254 Park Avenue HPC#37/03-0300
Takoma Park Historic District

SUBJECT: Historic Area Work Permit

HISTORIC PRESERVATION COMMISSION STAFF REPORT

PROPOSAL: Deck installation and porch enclosure

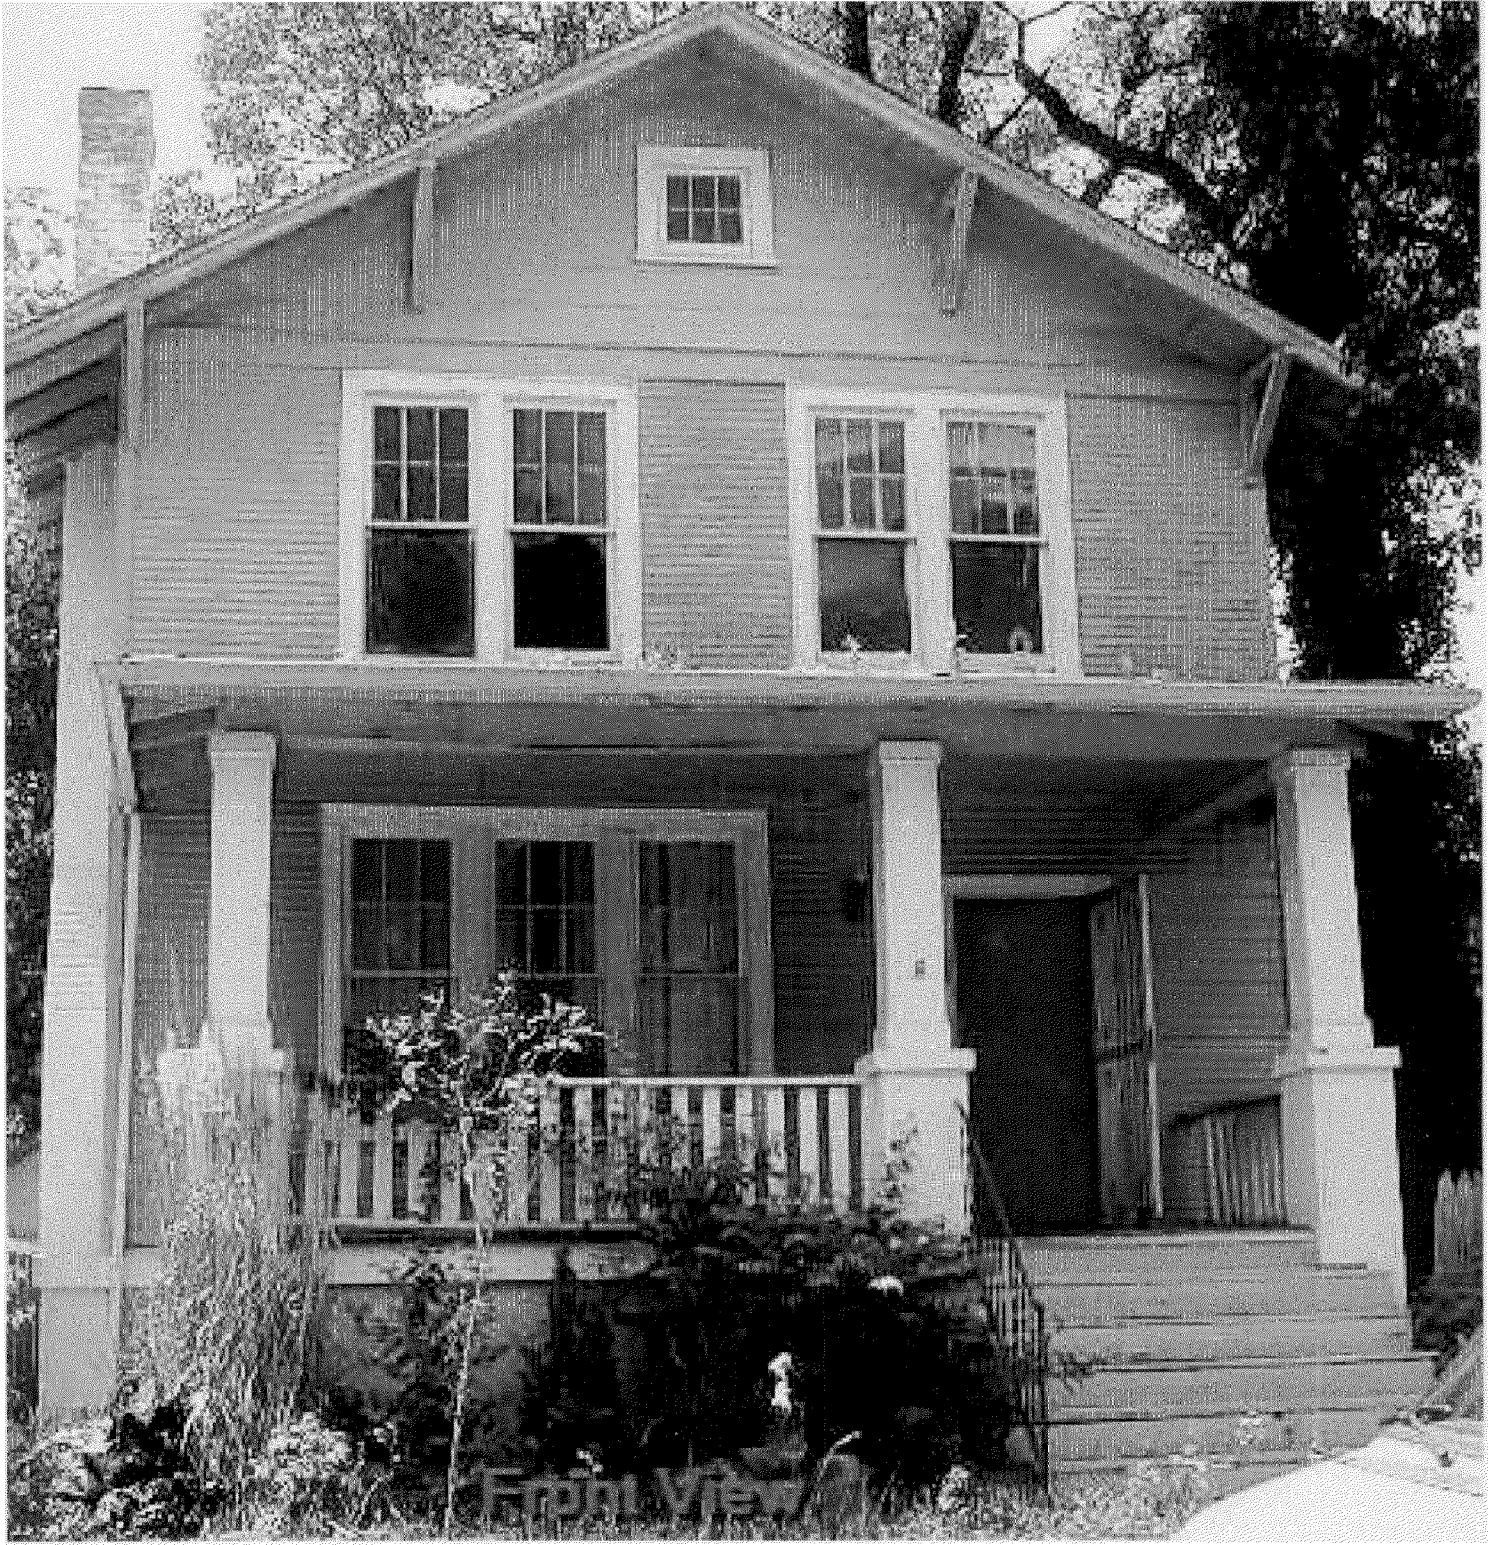
- ① Materials to be used for new deck and steps: Treated wood, No painted.
- ② Enclosed Porch Materials: wood siding and roof / shingles.
- ③ French door: French, Anderson doors, outside Finished Vinyl Clad.
- ④ Are existing steps from side porch to remain? Yes
